Service Kit 753-05471

Date: 3/29/2007

Subject: Rear Attachment Support Brackets for the 700 Series Lawn Tractor.

Models Affected: OEM-190-180 (38" and 42" decks) and OEM-190-182 (46" decks) Grass Bagger Attachments built prior to May, 1, 2007 (Date Code "...E017...")

FIGURE 2

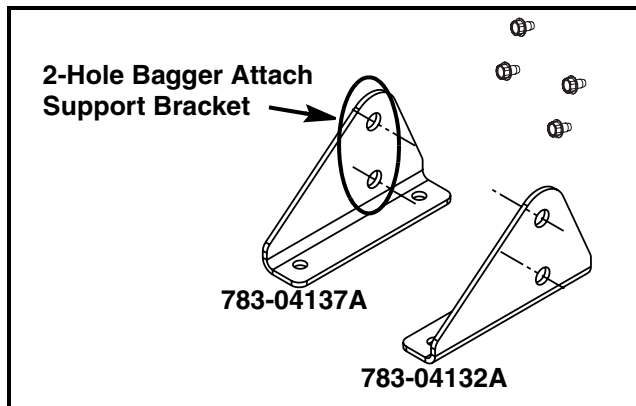
2. The 2-hole bagger attach support brackets (see Figure 2) that may have come with the Twin Grass Bagger Attachment package may be used to install the grass bagger on the 700 Series lawn tractors. Use this service kit in lieu of the 2-hole brackets and for Twin Grass Bagger Attachments that did not come with the 2-hole brackets.

6. At the rear of the tractor, if the brackets shown in Figure 2 are already installed on the tractor, remove and discard them and the 4 securing screws.

FIGURE 3

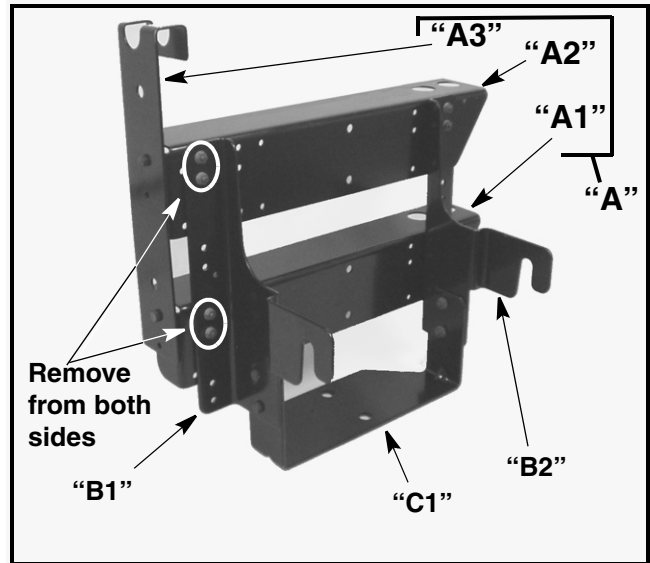
3. Refer to Figure 3. Remove parts "A1", "A2" and "A3" as a sub-assembly "A". Using a 7/16" socket and ratchet and 7/16" box wrench remove the eight (8) 1/4"-20 screws and hex lock nuts indicated in Figure 3, from the catcher support brackets "B1" and "B2". Set the "A" sub-assembly aside.

4. Using a 1/2" socket and ratchet and 1/2" box wrench, remove the four (4) 5/16"-18 screws and 5/16" securing the cross support bracket "C1" to the two (2) the catcher support brackets "B1" and "B2".

Discard the two (2) catcher support brackets "B1" and "B2". Retain the cross support bracket "C1".

FIGURE 4

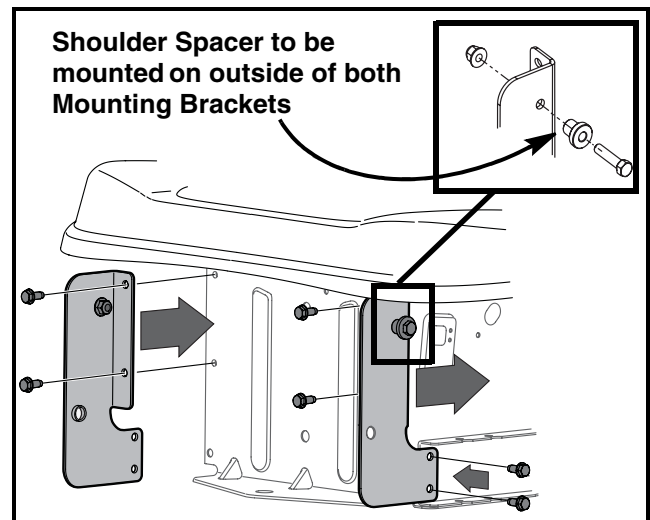
7. Starting on either the right or left side of the tractor, locate the appropriate side's Mounting Bracket (Item 7 or 8) and install the Mounting Bracket using four (4) Self-Tapping Screws, Item 1. Align and start all four screws before tightening. See Figure 4. Do the same for the other side.

8. Refer to Figure 4 Inset. For both Mounting Brackets, Items 7 and 8, install the Shoulder Spacer, Item 6, using a 3/8"-16 x 1.25" Hex Head Screw, Item 2, and a 3/8" Hex FlangeLock Nut, Item 4. Tighten securely.

FIGURE 5

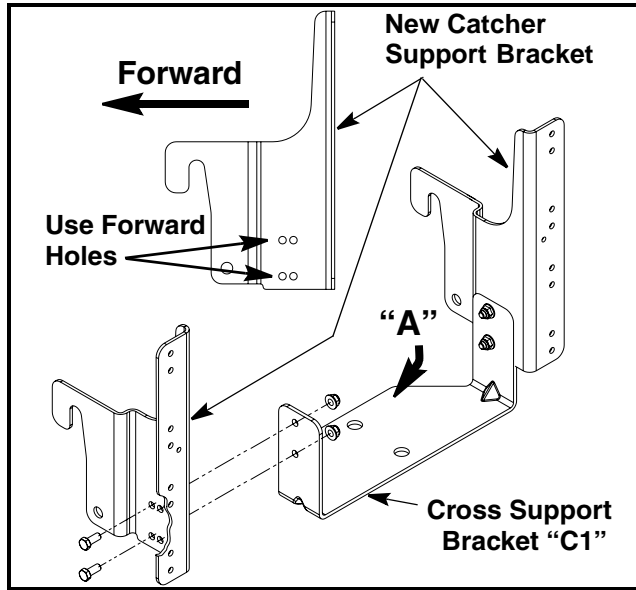
9. Using the two new Catcher Support Brackets, Items 9 and 10, supplied in this kit, and the four 5/16"-18 screws and lock nuts from Step 4, mount the cross support bracket "C1" (from Step 4) as shown in Figure 5. Note the orientation of the cross support bracket's extended lip "A". Do not tighten the screws at this time, allow brackets to move slightly.

The cross support bracket mounts in the two forward holes in the Catcher Support Brackets.
